Form 3160-5
(June 2019)UNITED STATES
DEPARTMENT OF THE INTERIOR
BUREAU OF LAND MANAGEMENTFORM APPROVED
OMB No. 1004-0137
Expires: October 31, 2021**SUNDRY NOTICES AND REPORTS ON WELLS**
Do not use this form for proposals to drill or to re-enter an abandoned well. Use Form 3160-3 (APD) for such proposals.

8. Well Name and No. ROSS DRAW 17 FED COM/707H

EOG respectfully requests an amendment to our approved APD for this well to reflect the following changes:

Revised Permit Information 06/08/2022:

WELL LOCATION AND ACREAGE DEDICATION PLAT

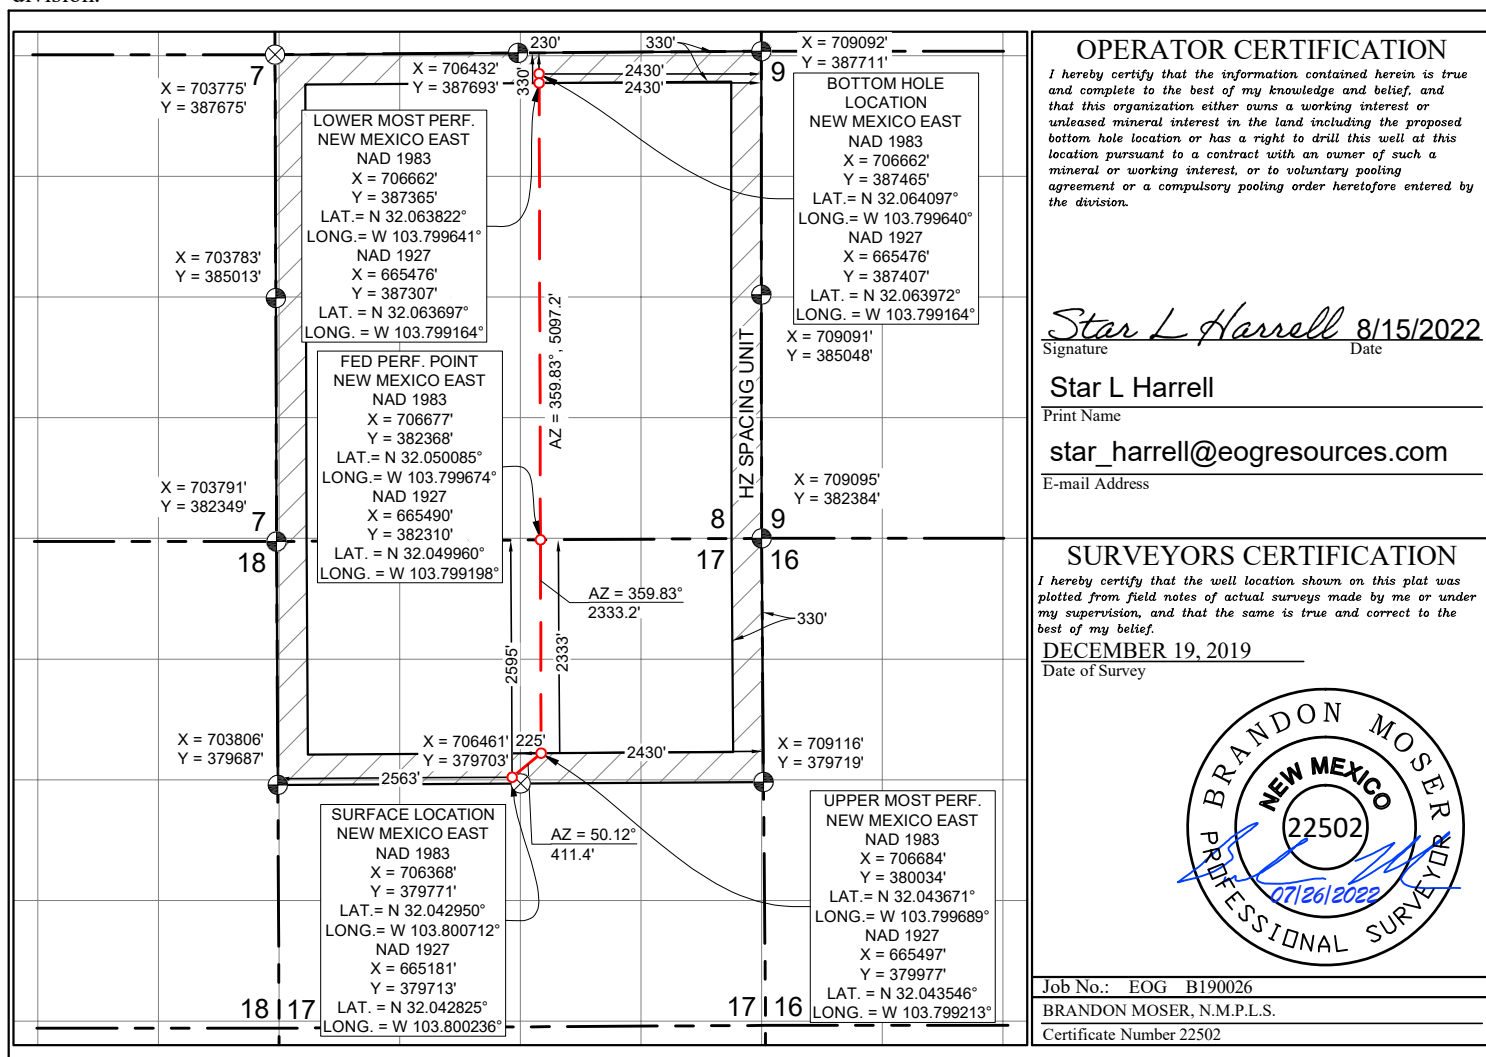
Change SHL from T-26-S, R-31-E, Sec 17, 2603' FNL, 2577' FWL, Eddy Co., NM, to T-26-S, R-31-E, Sec 17, 2595' FNL, 2563' FWL, Eddy Co., N.M.

Change BHL from T-26-S, R-31-E, Sec 8, 230' FNL, 2310' FEL, Eddy Co., NM, to T-26-S, R-31-E, Sec 8, 230' FNL, 2430' FEL, Eddy Co., N.M.

UL or lot no.	Section	Township	Range	Lot Idn	Feet from the	North/South line	Feet from the	East/West line	County
F	17	26 S	31 E		2595	NORTH	2563	WEST	EDDY

UL or lot no.	Section	Township	Range	Lot Idn	Feet from the	North/South line	Feet from the	East/West line	County
B	8	26 S	31 E		230	NORTH	2430	EAST	EDDY
